Work Order ID 135693

Item Name: Aft Crosstube - Mid Height 206L / L1 / L3 / L4, Blue

DRAWING NO. REV. A
D206-667-247 SHEET 1 OF 4
TITLE SCALE
CROSSTUBE ASS'Y (206L MID AFT) NTS

DRAWING NO. D206-667-247	TITLE CROSSTUBE ASS'Y (206L MID AFT)	REV. A	DART AEROSPACE LTD ENGINEERING ORDER		D.E.O. NO. D206-667-247-A-1	SHEET NO. SHEET 1 OF 1	SCALE NTS
DRAWN <i>q</i>	CHECKED <i>ASS</i>	MFG. APPR. <i>AD</i>	APPROVED <i>JMP</i>		DE APPR. <i>H</i>		
DATE 11.07.15	DATE 11.07.20	DATE 11.07.21	DATE 11/07/21		DATE 11.07.21

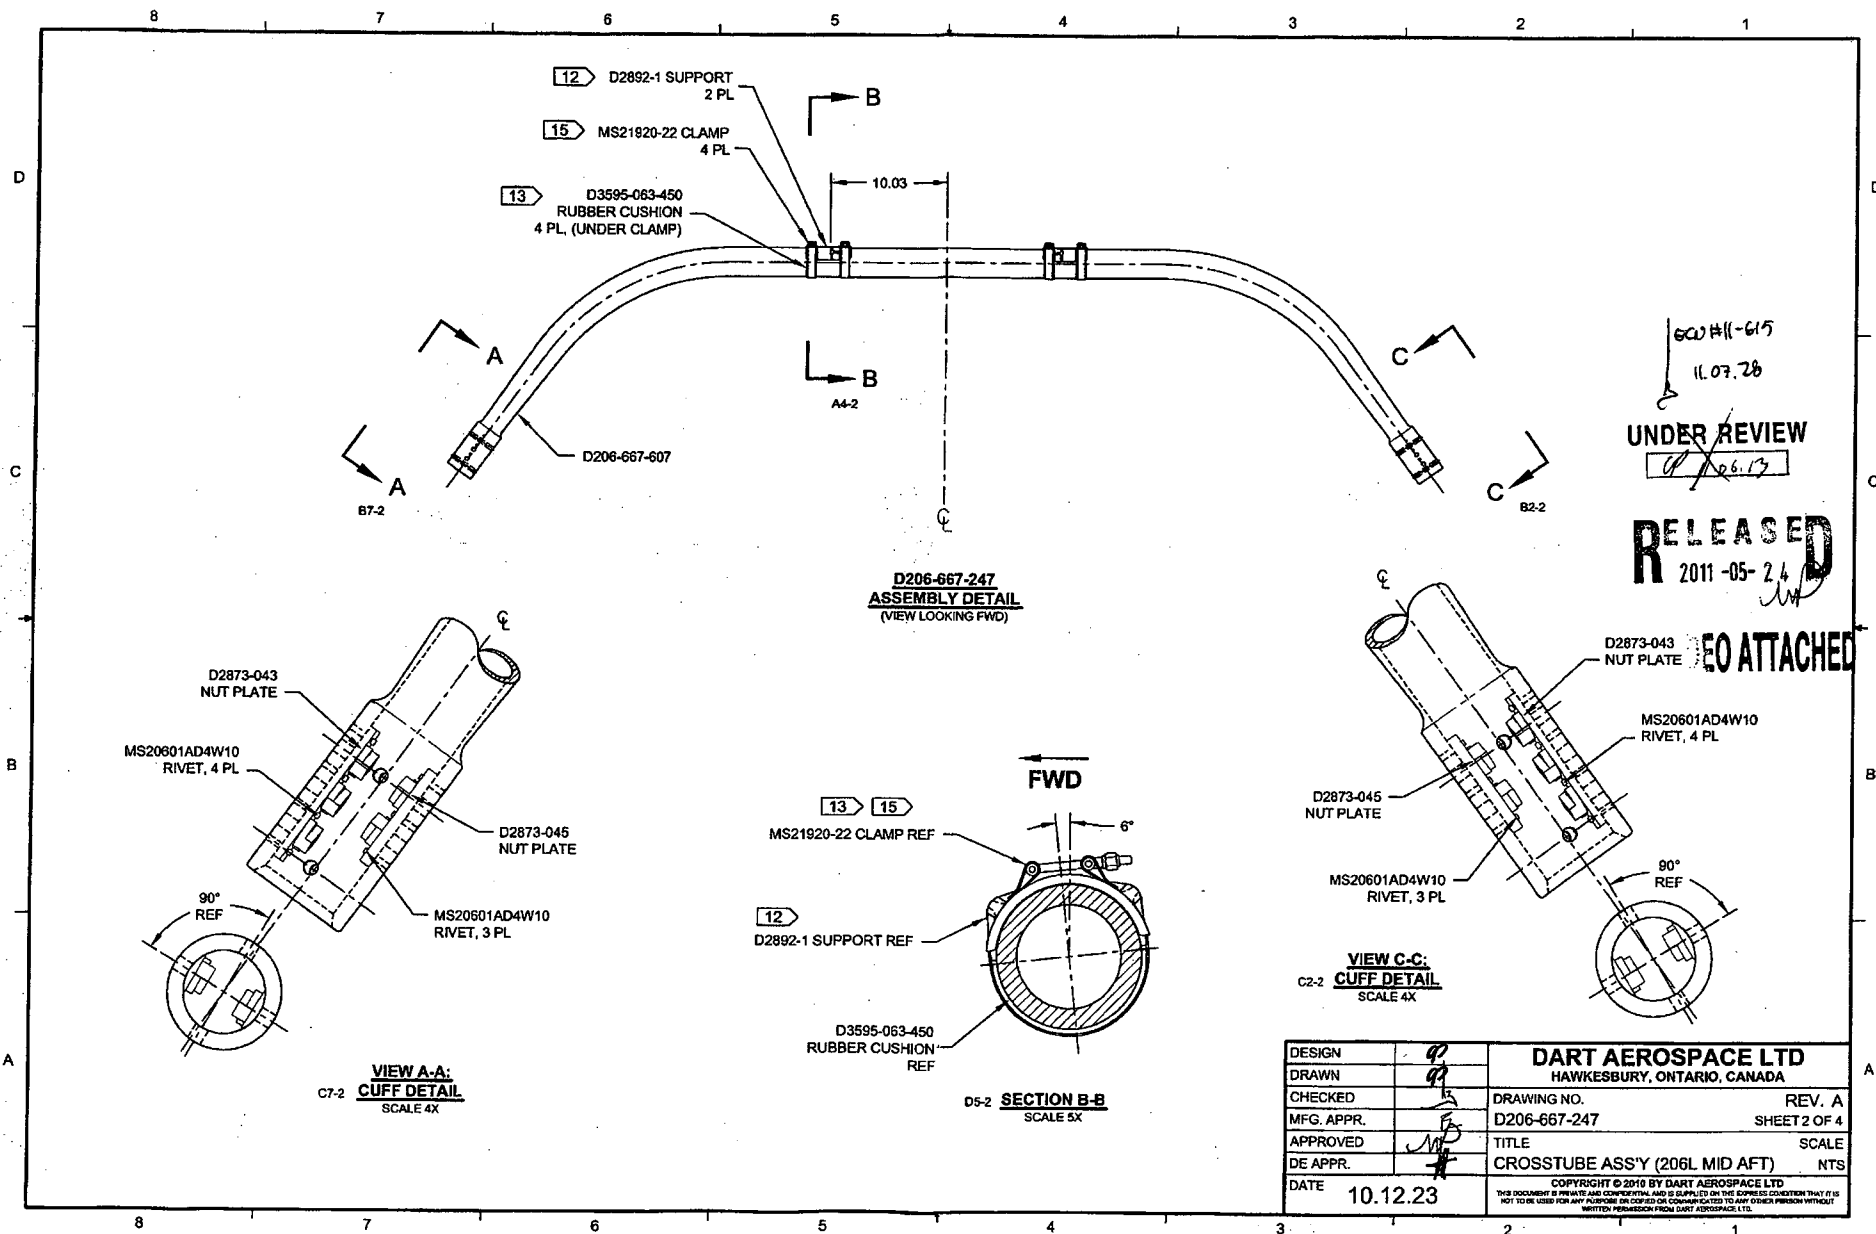
REPLACE MAGNOBOND WITH PROSEAL.

IS:

Item	Qty -247	Part Number	Description
9	A/R	PROSEAL 890 B-2	SEALANT, AMS-S-8802 CLASS B-2

WAS:

9	A/R	MAGNOBOND 6398	ROCKWELL SPECIFICATION RBO-120-023 ADHESIVE (TEXTRON/BELL SPEC. 299-947-100, TYPE II, CLASS 2 ADHESIVE)
---	-----	----------------	---

NOTE 12 & 15, SHEET 1 IS AMENDED AS FOLLOWS:

- 12) TO INSTALL D2892-1 SUPPORT: ABRASE MATING SURFACE OF SUPPORT AND CROSSTUBE WITH 180-GRIT SANDPAPER AND REMOVE RESIDUE WITH MEK (OR EQUIVALENT). APPLY A 0.04" TO 0.07" THICK LAYER OF PROSEAL 890 CLASS B-2 (OR AMS-S-8802 CLASS B-2) SEALANT TO MATING SURFACE OF SUPPORT.
- 15) TORQUE CLAMPS 80 TO 100 IN-LB. ENSURE AT LEAST 1.5 THREADS SHOWING IN SAFETY AND THAT NUT HAS NOT BOTTOMED-OUT AFTER TORQUING. **PRIOR TO PACKAGING, RE-CHECK TORQUE ON CLAMPS AFTER PROSEAL 890 SEALANT HAS CURED FOR 72 HOURS.**

- 12) INSTALL D2892-1 SUPPORT USING 0.03" TO 0.06" THICK LAYER OF MAGNOBOND 6398 PER QSI 015. LET CURE FOR 12 HOURS AFTER INSTALLATION AND PRIOR TO PACKAGING.
- 15) TORQUE CLAMPS 80 TO 100 IN-LB. ENSURE AT LEAST 1.5 THREADS SHOWING IN SAFETY AND THAT NUT HAS NOT BOTTOMED-OUT AFTER TORQUING.
